BUSH STREET TRAFFIC SIGNAL UPGRADE
BUSH ST AND PIERCE ST

SPECIFICATION NO.	0286J
DRAWING NO.	E-7.0
FILE NO.	78211
REV. NO.	2

BUSH STREET TRAFFIC SIGNAL UPGRADE
BUSH ST AND PIERCE ST SCHEDULE

SPECIFICATION NO.	0286J
DRAWING NO.	E-7.1
FILE NO.	78212
REV. NO.	2

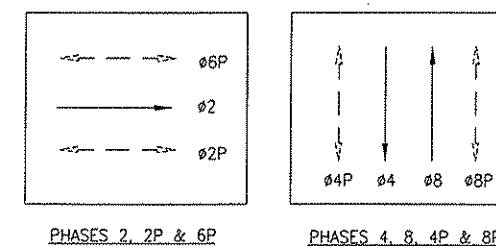
NO.	DATE	DESCRIPTION	BY	APP.
12/02	PCO-3: VARIOUS		TP	BC
10/02	PCO-1: NEW SERVICE		TP	BC
